Memorandum

To: Paul Woodard
From: Robert Montgomery, Linda Severson
Date: December 12, 2007
Re: Comments on the Planning Commission's 5 Stormwater Considerations

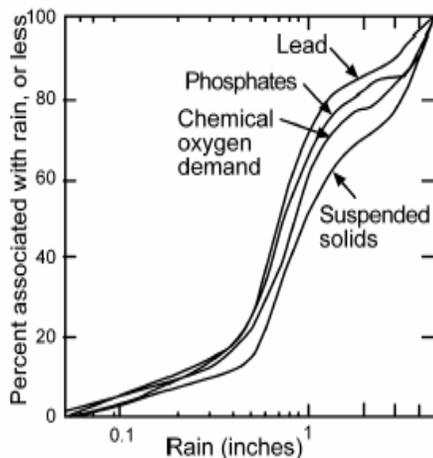
4. Provide a report on pollutant loading for varied storm events (2, 5, 10, 50, and 100 year) to compare effects on pond size and thermal characteristics and related matters.

Based on urban stormwater studies, relatively small storm events (1.5 inches or less, with return periods of less than two years) produce most of the mass of stormwater pollutant loading. Larger storms, such as the 2- through 100-years storms, do not produce the bulk of stormwater pollutant loading. Analysis of these larger storm events is more appropriate when considering peak discharge control for flood mitigation or channel erosion protection. The following discussion provides additional detail on stormwater pollutant loading rates.

The reason that small storms that occur frequently produce the bulk of pollutant loading rates is that they produce the runoff events that mobilize pollutants that have accumulated on the land surface. Between storm events, surfaces accumulate stormwater pollutants through varied means such as atmospheric and vehicular deposition. Rainfall impact dislodges pollutant particulates from the surface and transports them in the stormwater runoff. The great majority of rainfall events that produce runoff, and hence pollutant wash off, have a depths of less than 1 inch. The result is that the great majority of urban pollutant loading to streams and lakes is delivered by relatively small storms.

The graph below shows measured pollutant loads with varying rainfall depths measured in Milwaukee, Wisconsin for a medium density residential area. This data was published by Roger Bannerman of the Wisconsin DNR, and others, from data collected as part of the 1981 NURP study¹. As illustrated in the graph below, between 60 and 80% of total annual pollutant loadings for various parameters is the result of runoff from rainfall depths of 1 inch or less.
